Subject: Answers to the Questions asked by different Offerors for “FC Camp Remodeling” Solicitation # SPK330-13-P-5690 during and after site visit held on August 02, 2013.

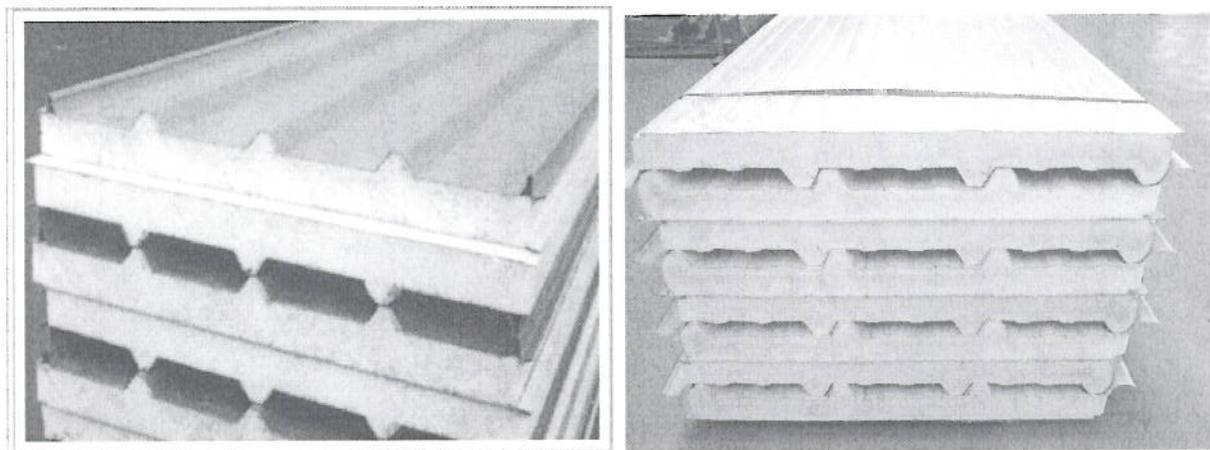
Q.21) Please clear the following sheet type or share any picture as local market names are not matching to the following specs,

- "Galvanized trapezoidal steel sheet+sandwich panel+16 SWG

Ans) Sandwich panel with corrugation. See pictures
